From: Sara Roediger, AICP  
Date: 2/10/2017  
Re: **Fire Station #4 Upgrade (City File # 14-020)**  
**Preliminary/Final Site Plan -- Planning Review#1**

From: Nancy McLaughlin  
To: Sara Roediger  
Date: 02/07/17  
Re: Project: Fire Station No. 4 Review #1  
Parcel No: 70-15-17-128-022  
File No.: 14-020  
Applicant: City of Rochester Hills

From: Jason Boughton, AC, Engineering Utilities Coordinator  
To: Sara Roediger, AICP, Manager of Planning  
Date: February 16, 2017  
Re: Fire Station #4, City File #14-020, Section #17  
Site Plan Review #1

CITY OF ROCHESTER HILLS  
STANDARD DETAIL FOR:  
Sight Distance Pathways

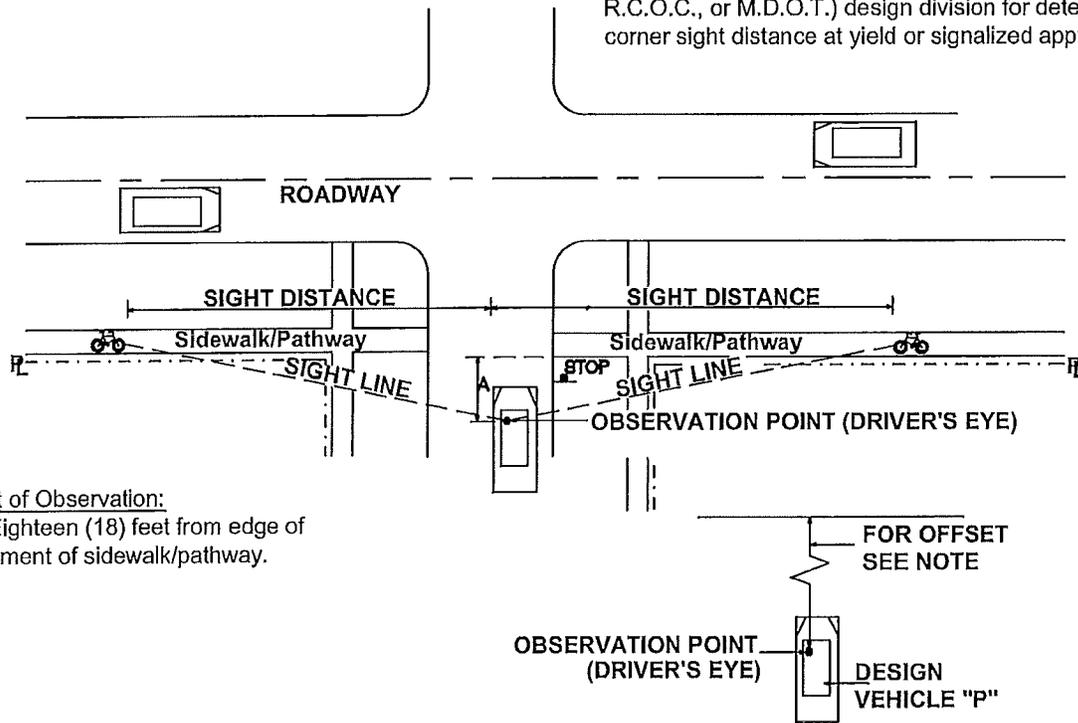
1. Coordinate the design and replacement of the traffic signal heads with RCOC and include traffic signal notes on the plans. Traffic signal plans will be required to be included with the approved construction plans.
2. Label Walton Boulevard on all plan sheets and identify it as being under the jurisdiction of the Road Commission for Oakland County. A RCOC right-of-way permit is required for all work within Walton Boulevard right-of-way.
3. The existing heavy-duty concrete pavement is 9 inches thick. It is recommended that the proposed heavy-duty concrete section be a minimum 8-inch thick. Please revise details accordingly.
4. Include the required sight lines on the landscape plan per the attached details. Anything with the sight lines must be less than 30 inches in height.
